To: Rodion Iwanczuk, Planner, Loudoun County Division of Community Information and Outreach

From: Wayne Lee, Purcellville Assistant Town Planner

**Loudoun County Public Schools
Special Exception Statement of Justification
Western Loudoun County High School (HS-3)
Fields Farm Property
June 29, 2006
Updated December 12, 2006
Updated February 15, 2007**

Responses to Purcellville's June 5, 2006 HS-3 Comments

**Fields Farm High School
 LCPS Site Traffic Volumes
 Purcellville, Virginia**

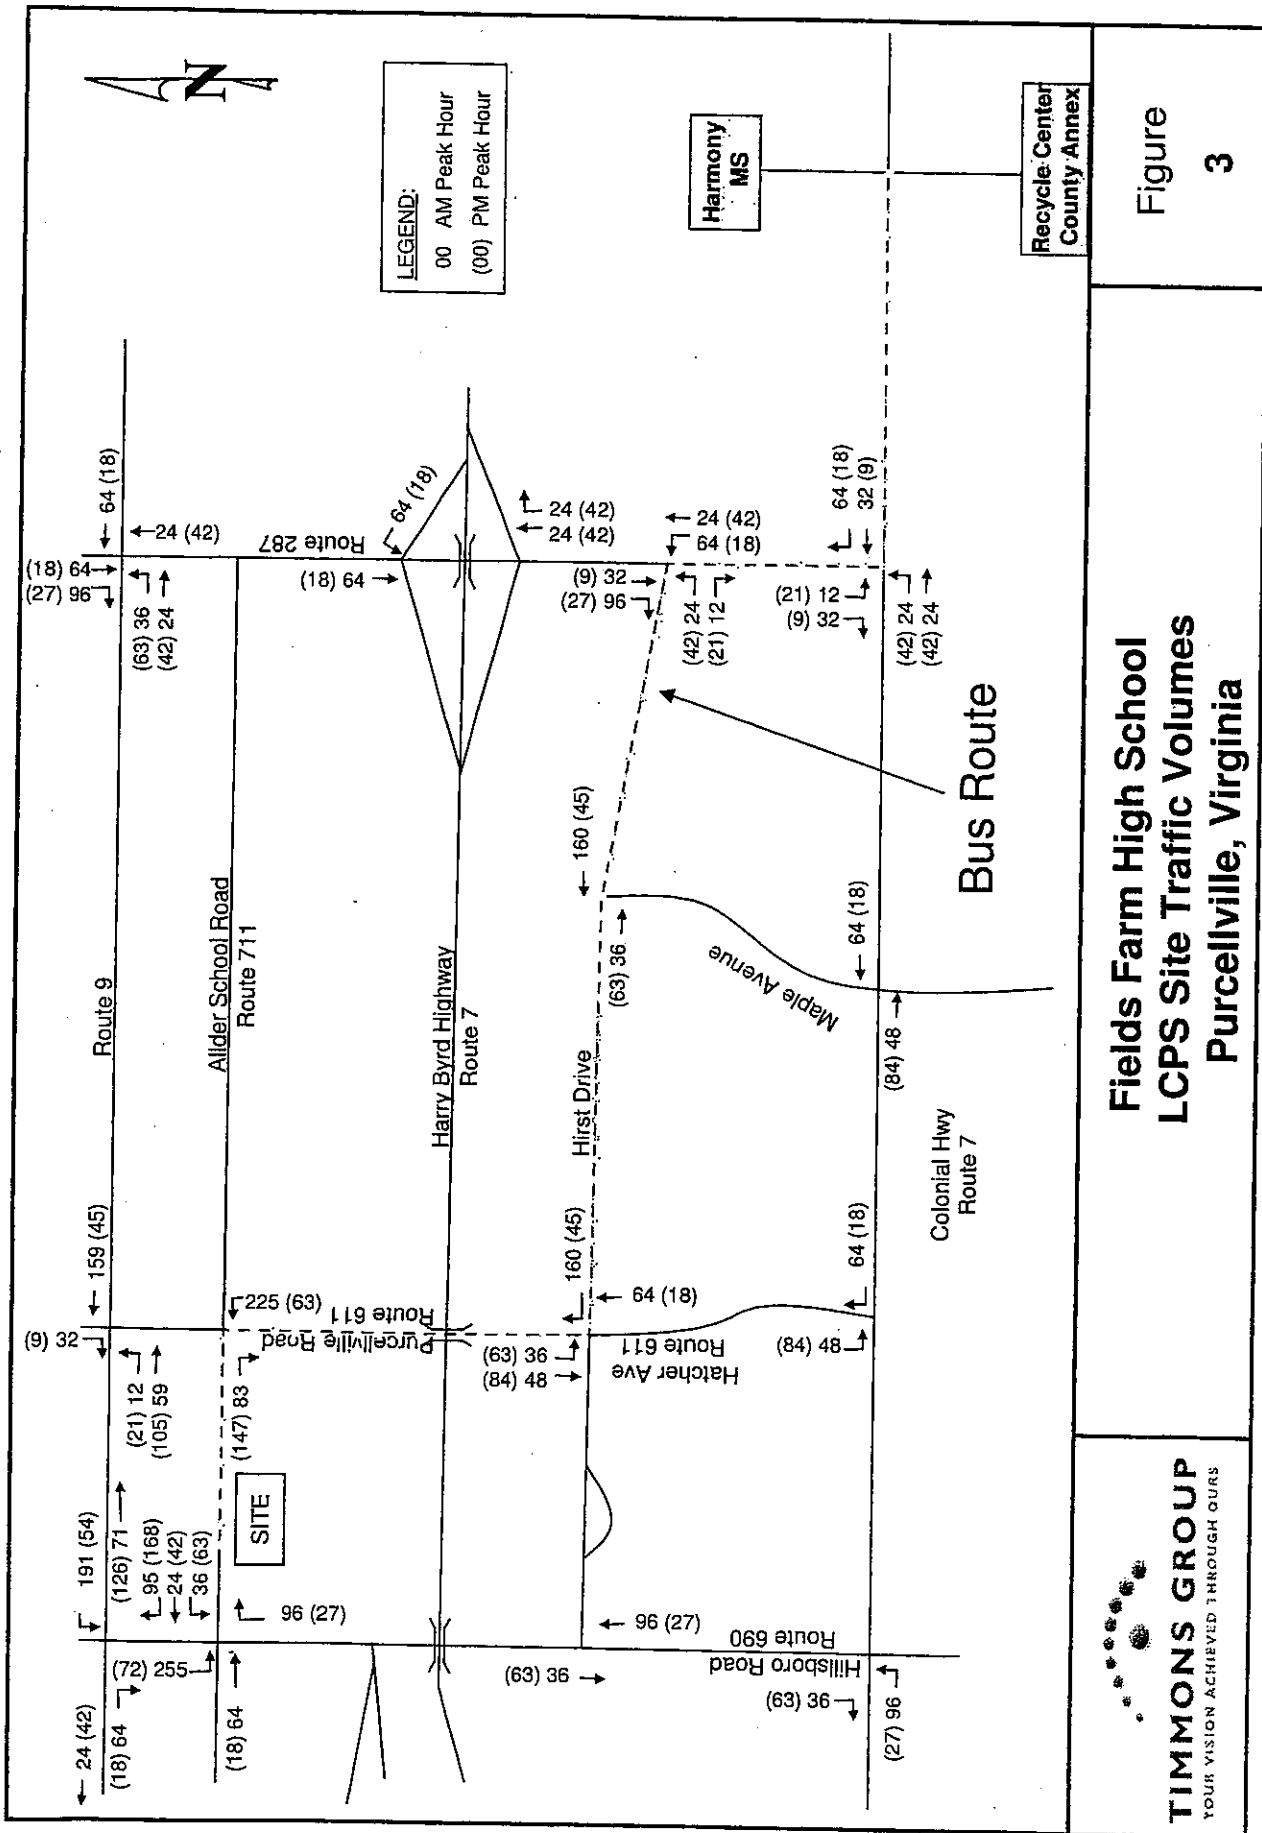
Comment 13: Trip generation appears to be reasonable, but it might be helpful to supplement the ITE trip generation equations with local data from other Loudoun County high schools. This area's socioeconomic demographic is predominantly affluent and it would be expected that there would be more vehicles per household, which could result in a higher trip generation rate for students.

Comment 17: It would be helpful to show a separate directional distribution for projected bus traffic. Are bus routes factored into total traffic? How about probable routes faculty and staff will take?

A revised site-generated traffic estimate was prepared (see Table 1C). This data was also used as a basis to prepare Figure 3 (attached), which summarizes estimated school traffic at the analyzed intersections assuming the increased site-traffic based on the Loudoun County data. The Loudoun-specific trip generation rates resulted in a 218 vehicle trip increase during the AM peak and 151 vehicle trip increase during the PM peak. Given the distributed nature of the high school traffic, the additional impact to a majority of the intersections is minimal, equating an additional 20-30 vehicles at most intersections. The most heavily impacted intersections are the Route 690/Allder School Road, Route 611/Allder School Road, and Allder School Road/HS Entrance intersections. With the proposed improvements, each of these intersections operate at LOS "C" or better, a full letter grade about the required minimum. It is not anticipated that the additional vehicle trips would result in unacceptable levels of service/operational conditions at these locations.

Response: It is anticipated that bus traffic will follow the route highlighted on Figures 2 and 3 (attached); this information was also shown on Figure 4 in the original traffic study. Bus routes were taken into consideration with regard to traffic flows and operations. The remaining site traffic was distributed based on the location of the student body within the attendance zone.

Route 711 HS
Proposed Roadway Improvements
Purcellville, Virginia

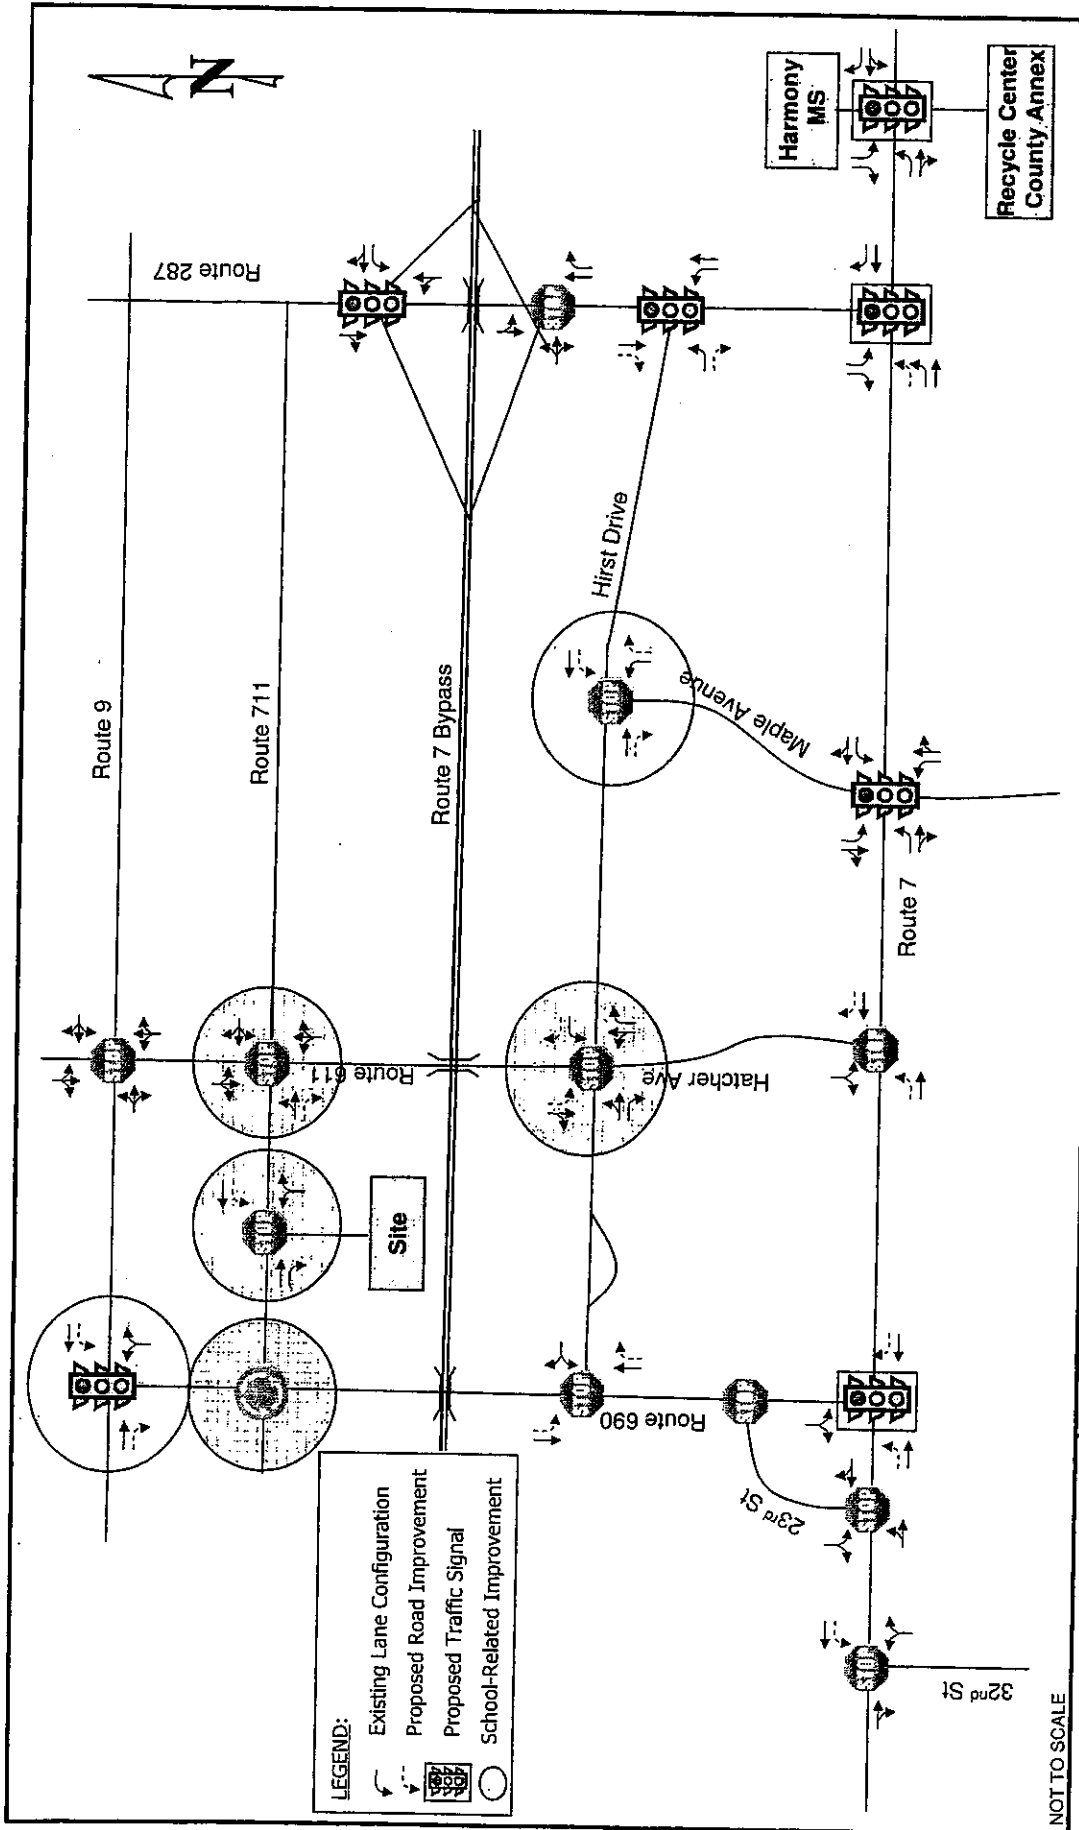
3. Figure 4 - Provide the assumptions used to generate the site traffic distribution estimates for routes to the proposed high school HS-3.

Figure 4

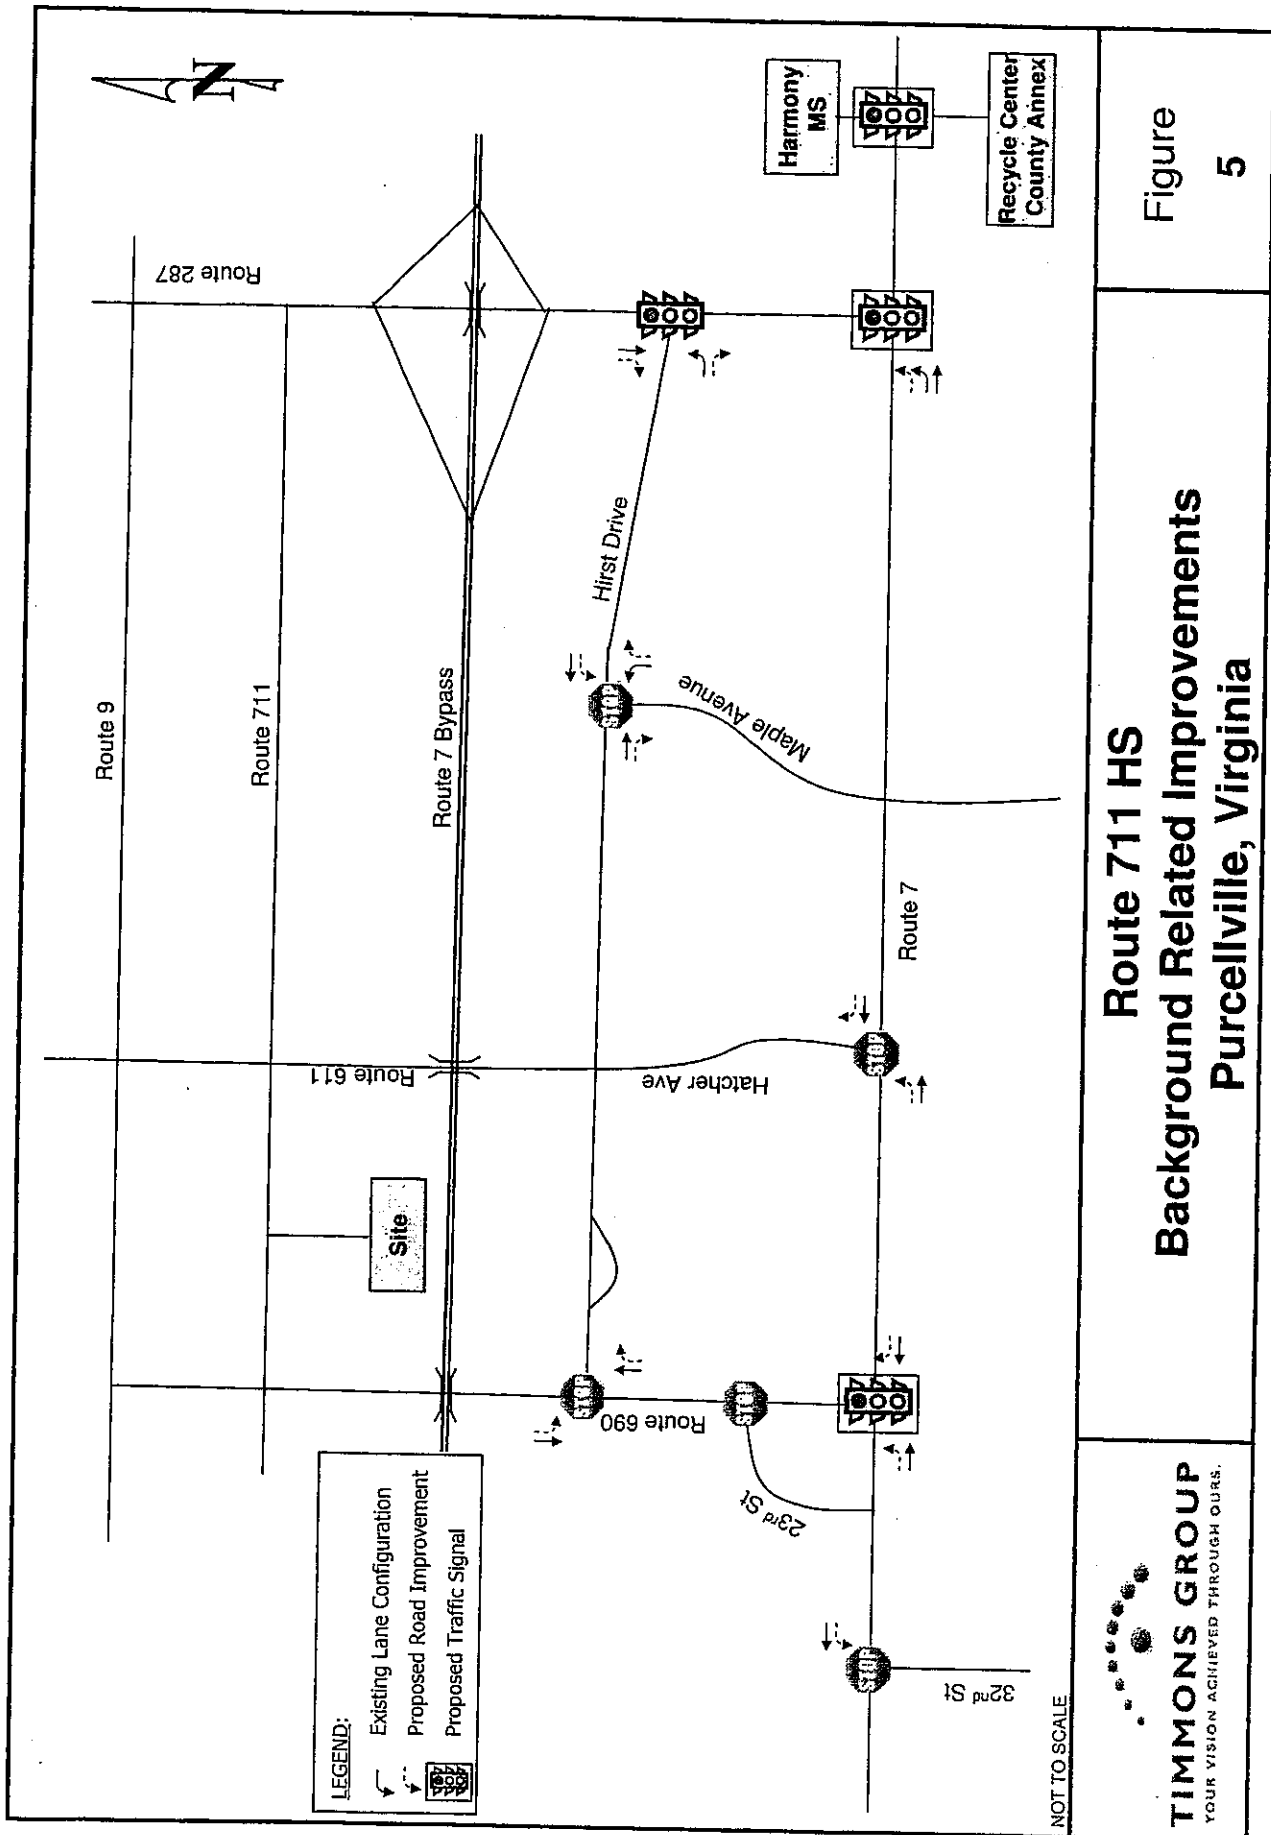
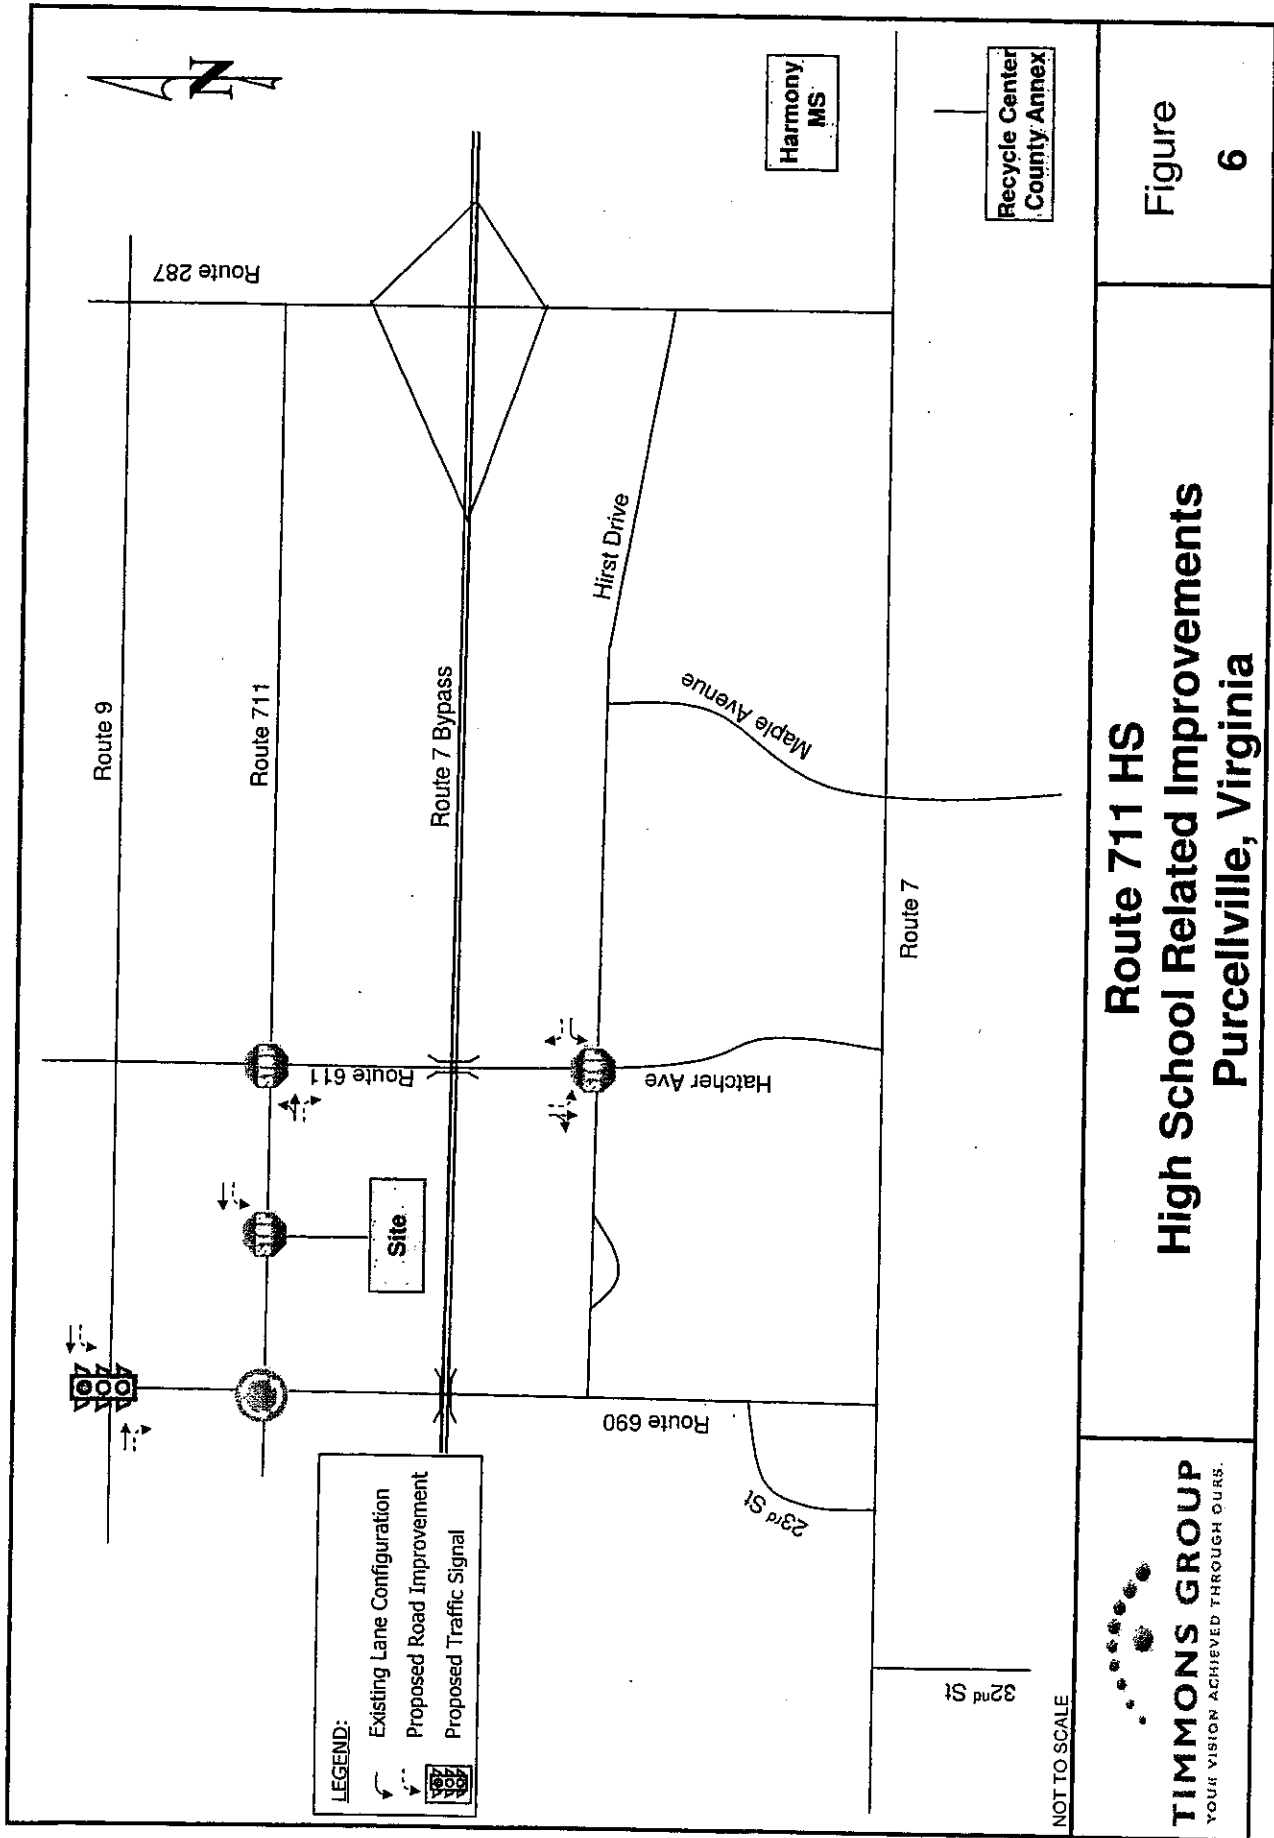
Comment 21: It would be helpful to show a graphic depicting the proposed intersection improvements, both for the background and total future conditions.

Response: Figure 5 (attached) shows those intersection improvements which are warranted due to background traffic volumes. Figure 6 (attached) shows those improvements which are warranted by traffic generated by the proposed high school.
